SUNDRY NOTICES AND REPORTS ON WELLS (DO NOT USE THIS FORM FOR PROPOSALS TO DRILL OR TO DEEPEN OR PLUG BACK TO A DIFFERENT RESERVOIR. USE "APPLICATION FOR PERMIT" (FORM C-101) FOR SUCH PROPOSALS.) 1. Type of Well: Oil Well <input type="checkbox"/> Gas Well <input type="checkbox"/> Other Injection		WELL API NO. 30-025-05764

CANCELLING PLANS TO P&A WELLBORE AND PLAN TO RETURN TO PRODUCTION.

Well Name: NORTH MONUMENT G/SA UNIT #1516

Action 559189

Schematic - Current

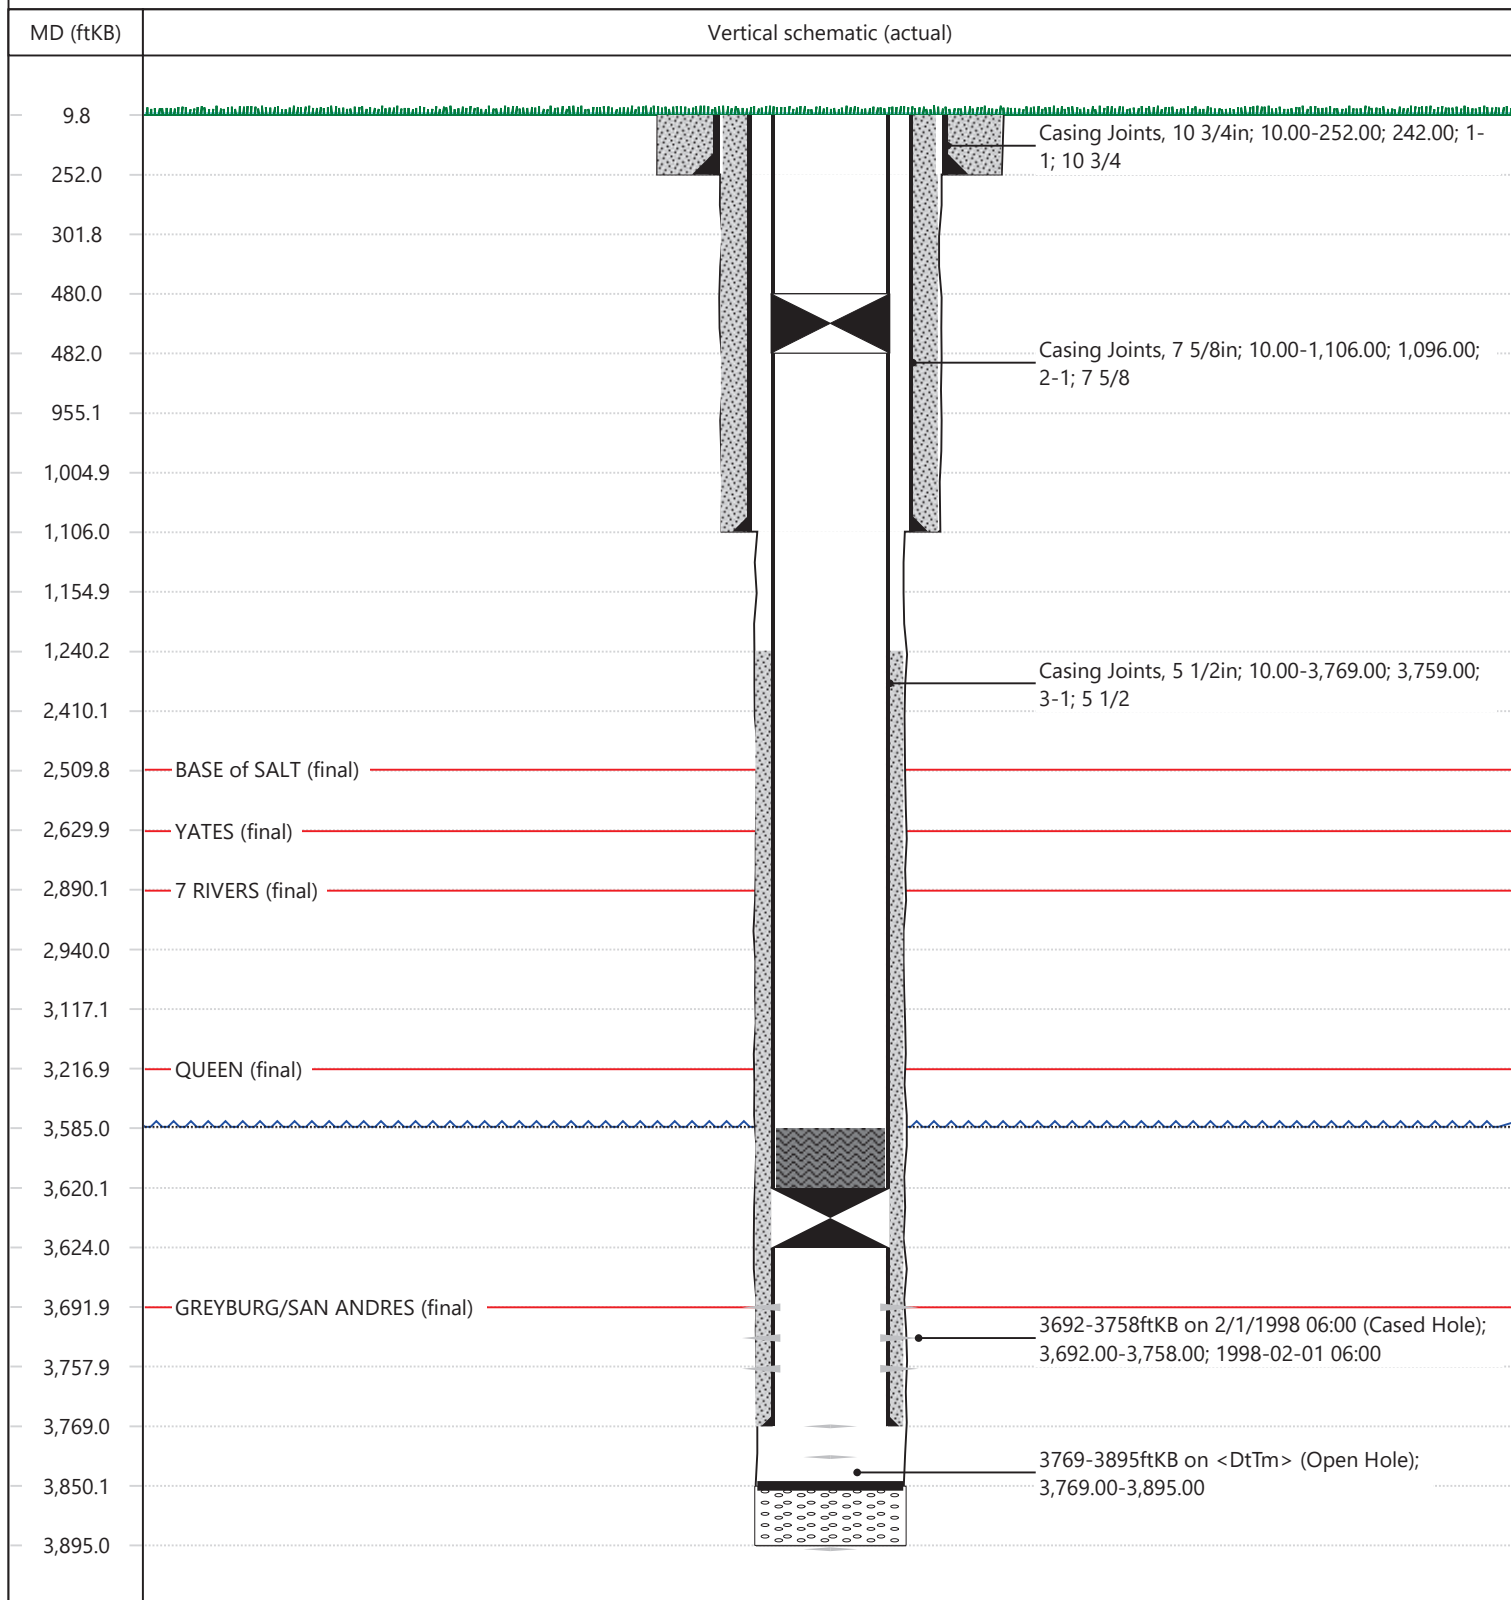
Requesting permission to RTP well. Proposed procedure is below and Current and Proposed WBDs are attached.

Schematic - Proposed

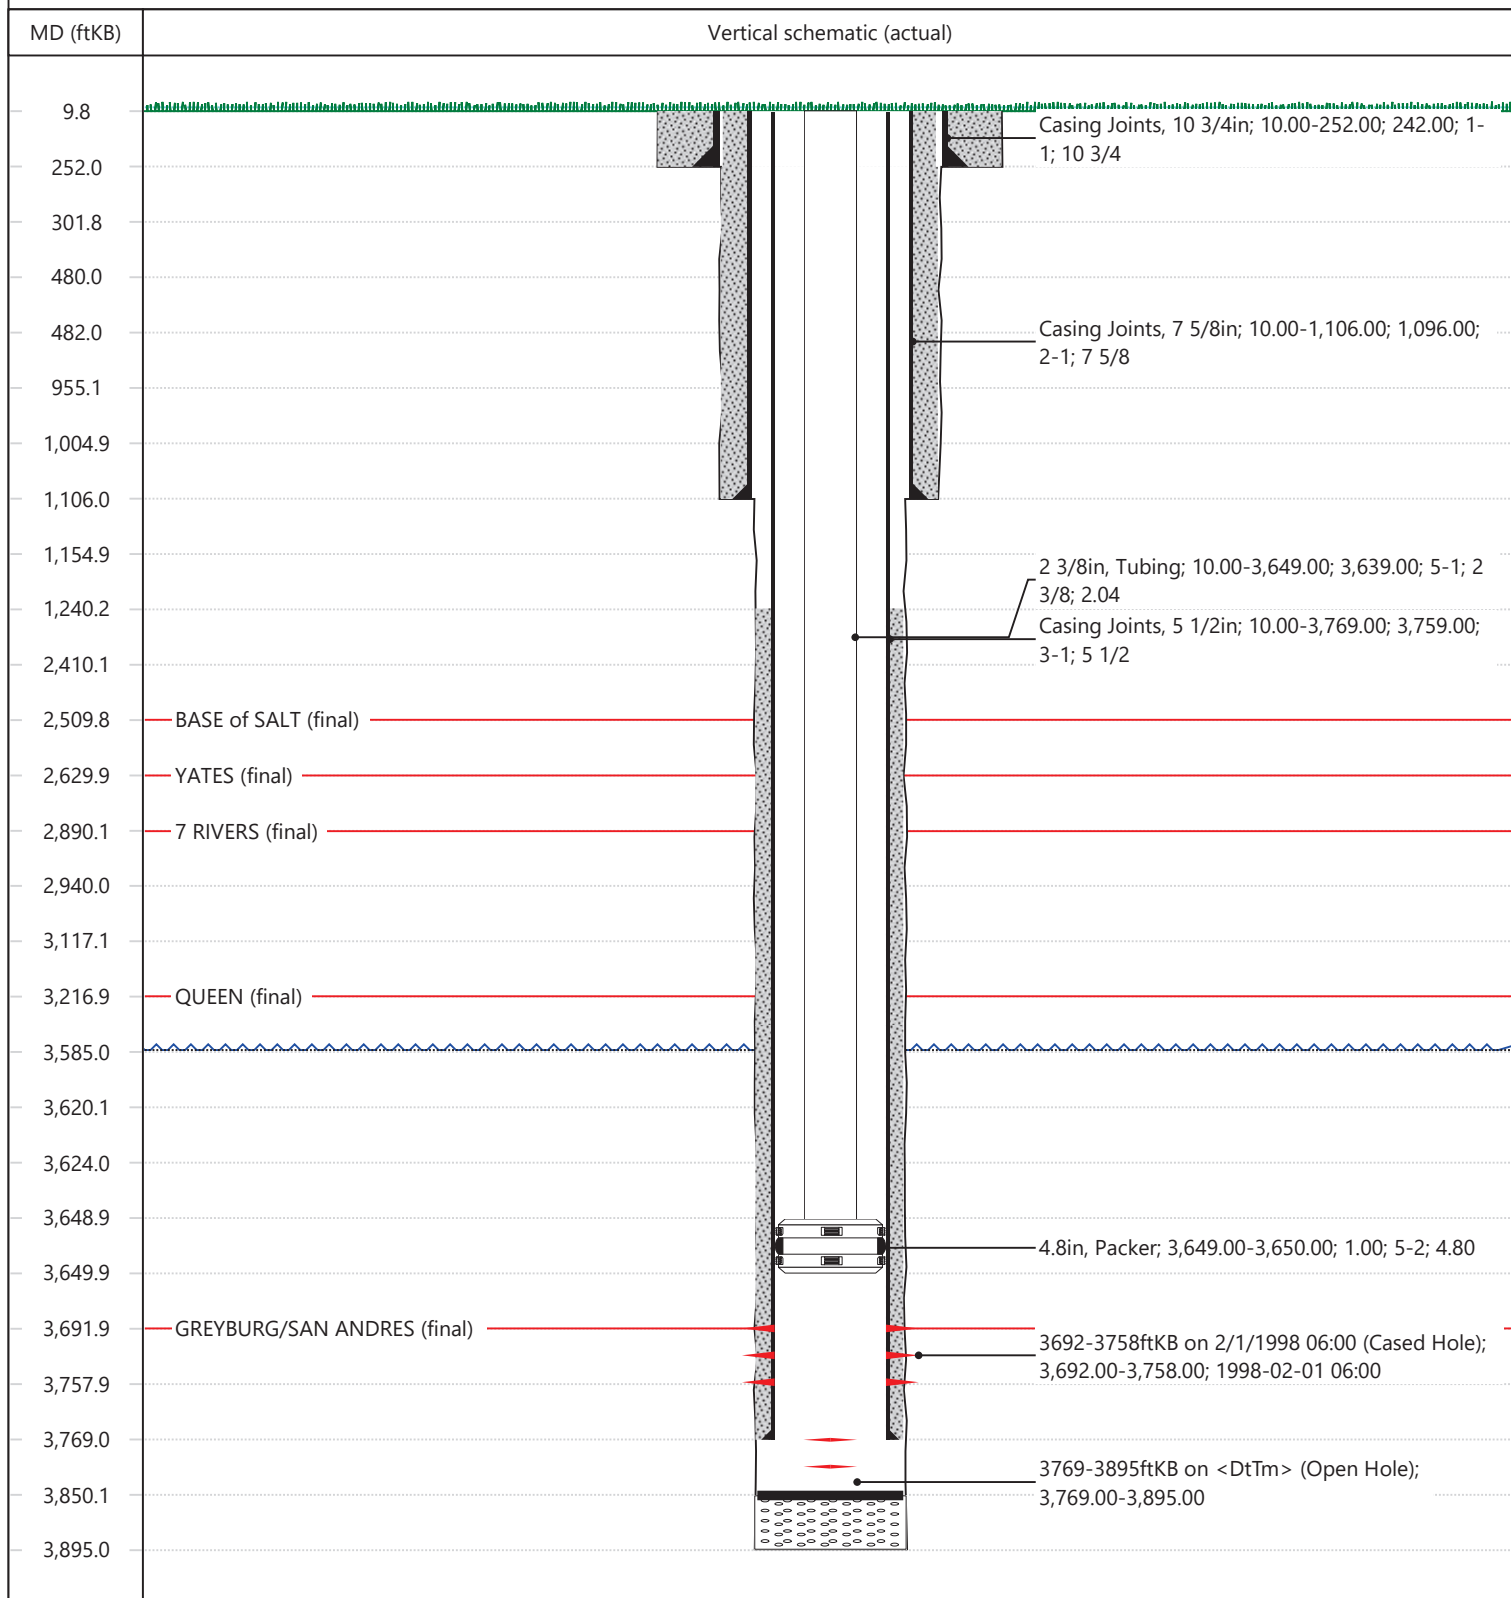
- MIRU, ND/NU, function test, order necessary kill fluid based in shut in pressures
- RIH and latch onto RBP at 480'. Unset and monitor. Pump kill if necessary.
- Utilize RBP to test casing, if leaks are located Hilcorp will reach out to the NMOCD for permission of plans forward.
- RIH with bit and tag TA cement, circulate, drill out to 3595', and clean out to ~3850, then test casing.
- RIH and pump 10,000 gal NEFE 15% HCl acid job with vendor recommended additives.
- RIH with new 2.375" INJ tubing and INJ packer. Set packer at ~3650'. INJ perfs are 3692' to 3850', Packer will be set between 3592 and 3650'.
- Contact NMOCD with 24 hour advance notice, and perform witnessed MIT. Return to injection.

Created By	Condition	Condition Date
anthony.harris	No tubing upsize permitted (2.375 inch approved for use)	3/27/2026
anthony.harris	MIT required with OCD witness	3/27/2026
anthony.harris	If actual packer setting depth is different from the depth in this Sundry (3649 feet), submit C-103 Subsequent report and attach an updated wellbore diagram for OCD well file records.	3/27/2026
